NAVY ELECTRONICS LAB SAN DIEGO CALIF
EVALUATION OF BATHYTHERMOGRAPH MODELS OC-1C/S AND OC-2C/S.(U)
JAN 58 J E ROBERSON
NEL-827

EVALUATION OF BATHYTHERMOGRAPH MODELS OC-1C/S AND OC-2C/S.

U. S. NAVY ELECTRONICS LABORATORY, SAN DIEGO, CALIFORNIA
A BUREAU OF SHIPS LABORATORY

Evaluate preproduction samples of surface-vessel bathythermograph models OC-1C/S and OC-2C/S for compliance with specifications.

Figure 1. PP-1 Calibration trace.

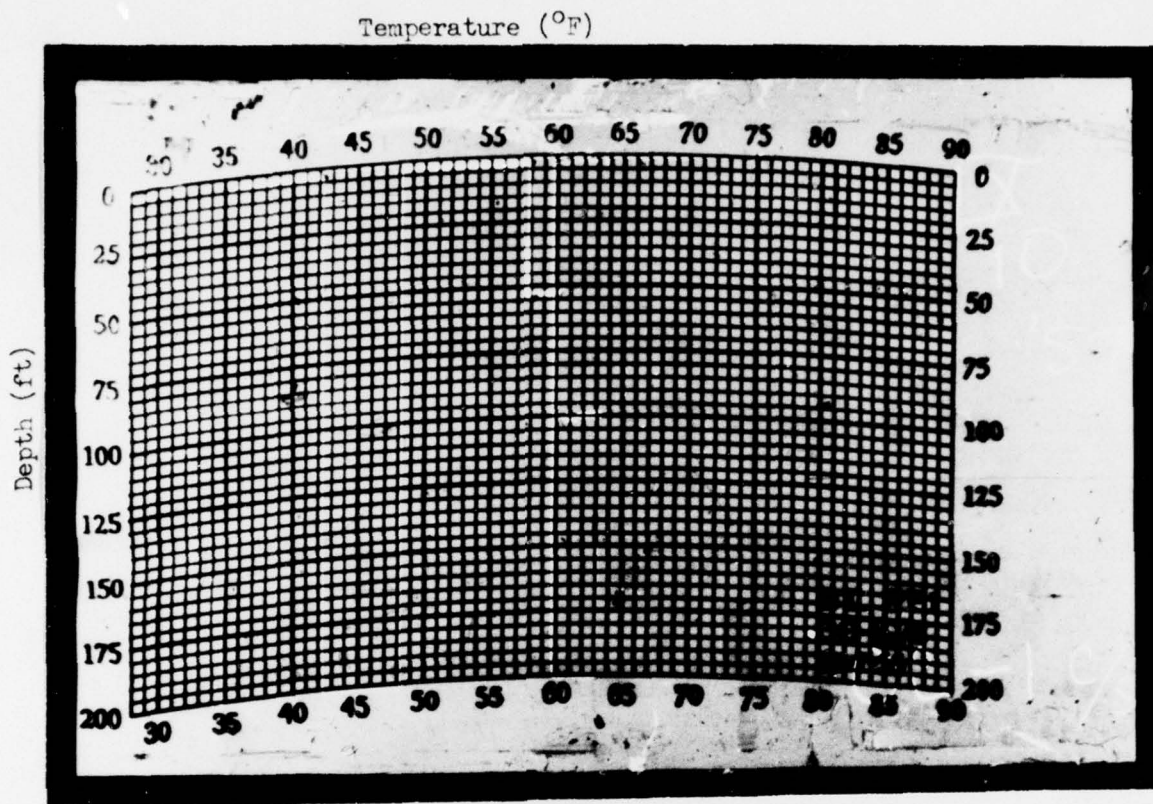
1. The layout of both the PP-1 and PP-2 grids is good. However, the PP-1 (fig. 1) must be considered unacceptable because the lines, which vary in width from 0.0025 to 0.0045 inch, are much too wide for reading to 0.1°F. The calibration trace is nearly hidden. Wide grid lines can be caused by wide harp lines, shadows, or overexposure.

1. Make grid lines 0.0015 inch wide or less, except for the periodic heavier lines, which should not exceed 0.003 inch in width. Improve the grid-making apparatus to give the thin lines without extreme underexposure.

Figure 2. PP-2 Sea trial trace.

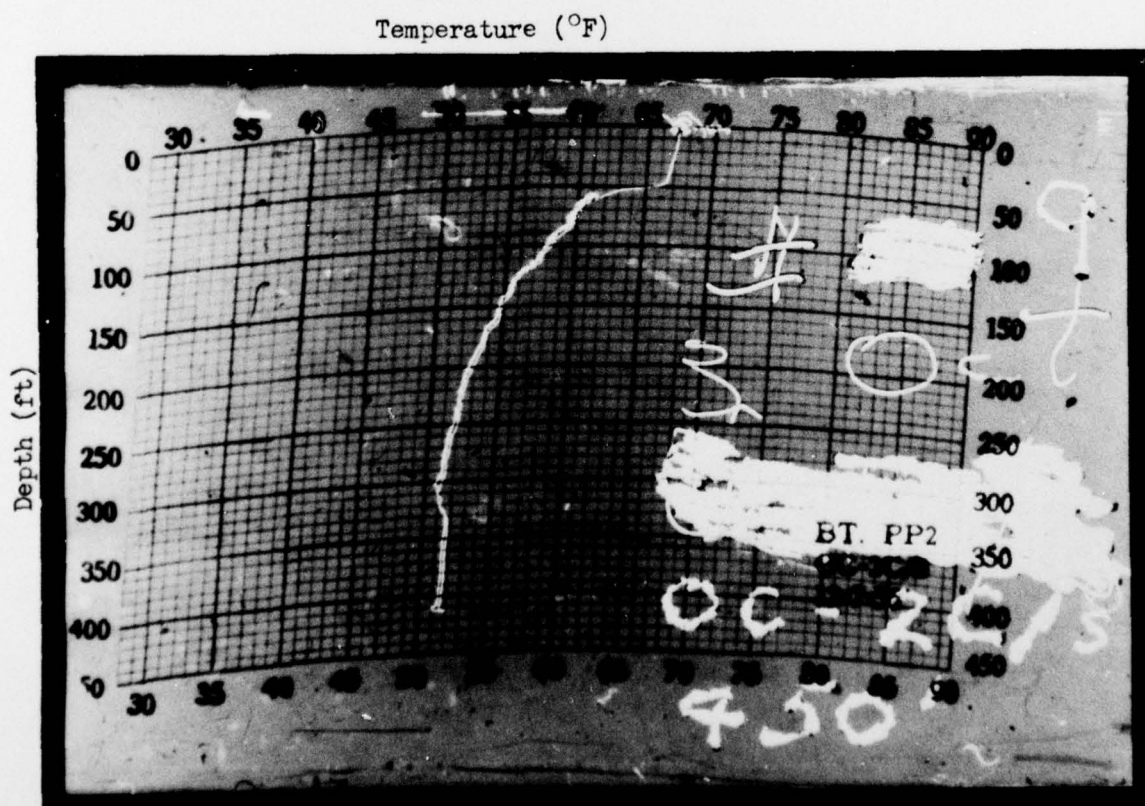
The PP-2 grid (fig. 2) is satisfactory; its lines are thin (0.002 inch and less) as a result of underexposure. In the interest of accuracy, it is preferable to err on the thin side rather than the thick, and underexposure is a means to this end. However, the grid-making apparatus should be improved to make thinner lines without underexposure. The names of the grid units should be applied to both axes when there is room.

The depths reached were similar to those of table 1-1 of the instruction book.¹ The PP-2 sample dived as deep as 410 feet at 13 knots with 1100 feet of line out (fig. 2).

The traces of figure 2 have about 0.3°F hysteresis. The trace of decreasing depth is marred by stylus

vibrations excited from the ship, cable, and currents of water around and through the BT. Figure 2 is representative of a BT in good working order.

Figure 3. PP-2 Calibration trace

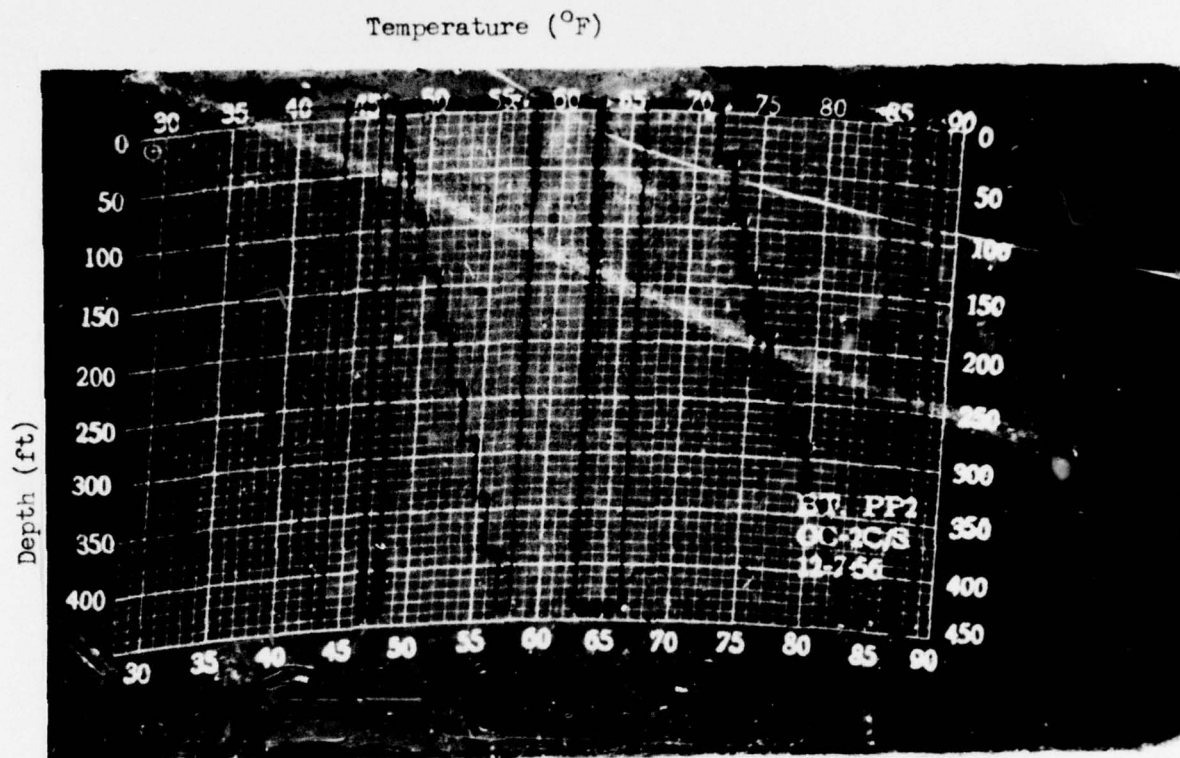
After the adjustment the calibration was checked from the trace of figure 3 and another trace, and plotted in figure 6. (The slide and grid were not properly aligned when figure 3 was taken.) Test No. 1 was conducted with increasing temperature and Test No. 2 with decreasing temperature. The plot shows the average error after correcting for the 3°F adjustment. The original temperature calibration did not meet the specification because the error varied over a span of 1.2°F between 30° and 90°F. The depth errors were 2 feet and less, meeting the 1 per cent limit of 4.5 feet. The pen lifter operated at 60 feet. Hysteresis data were not obtained during calibration because of the close test scheduling. The sea trials and pressure-element tests give some hysteresis information, and the vertical spread of the points in figure 6 indicates the variation of temperature error for repeated measurements.

of the finite stylus point curvature. If the stylus is too dull for the coating, the smoke will build up in front of the stylus, hindering it and frequently producing a very wide trace. The smeared traces of figure 3 show what can happen, although this case was aggravated by the antifreeze in the calibration water. A thick coating requires more skunk oil, which makes buildup more likely. Also, a thick coating tends to flake like a thick coat of paint. A thin coating has the advantages of a sharper trace, less hysteresis because of less friction, and less buildup. The thin coating reduces the contrast for photography. However, it is much better to get a fair photo of a good record than to get a good photo of a poor record. The best coating is the thinnest that meets minimum requirements for reading and photographing.

Use as light a smoke coating on the slides as can be photographed by the standard procedures. Avoid excessively greasy smoke and excess skunk oil.

FIGURE 1
OC-10/S, PP-1
TEMPERATURE CALIBRATION
O - TEST #1
X - TEST #2
NOTE: POINTS CONNECTED
BY LINE SEGMENTS ARE
AT ENDS OF FULL DEPTH
ISOTHERMAL TRACES

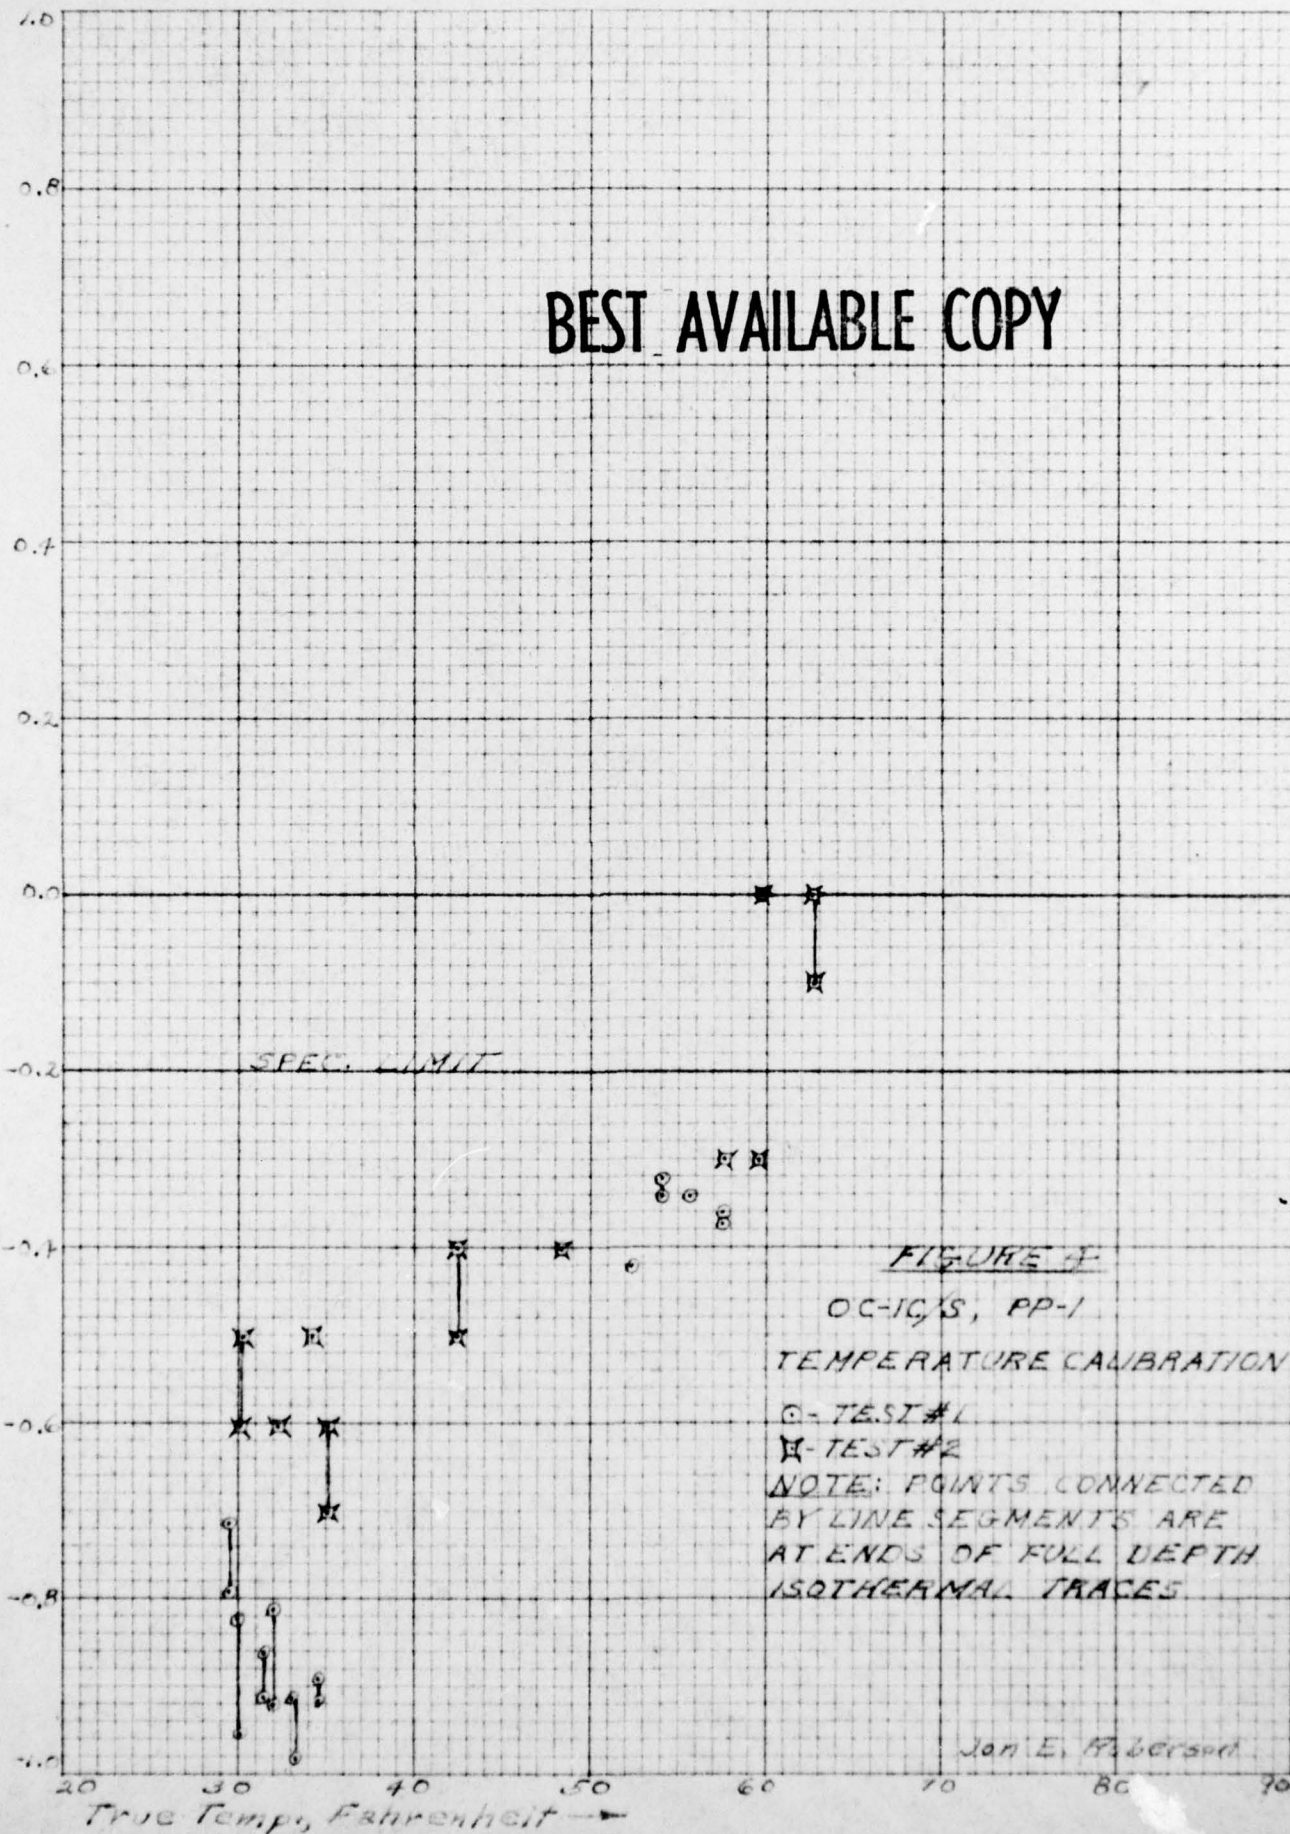
The two tests of the PP-1 produced traces similar to figure 3. Both tests were interrupted by failures of two successive immersion heaters. Figures 4 and 5 show that the temperature and depth errors exceed the specification limits of 1 per cent of full depth and 0.2°F between 34°F and 90°F. The average errors for the two tests vary by 0.3°F and 1.5 feet of water. The stylus probably suffered a change of adjustment between tests. The pen lifter operated at 60 feet as required by the specification.

The factory calibration errors appear as systematic variations over the grid range. Figures 4 and 6 show

similar slopes, indicating calibration error. The vertical line segments indicate isothermal traces on the temperature calibration plots. The isotherms read from 0.1 to 0.2 higher at full depth than at sea level in four out of seven cases for PP-1 and six out of seven cases for PP-2. This was probably caused by stylus flexure. The slope of figure 5 suggests a linear calibration error. The systematic errors are more serious than the average errors because they change the shape of the traces and cannot easily be corrected.

1. Improve the temperature calibration to eliminate the variation of temperature error with temperature shown by figures 4 and 6.
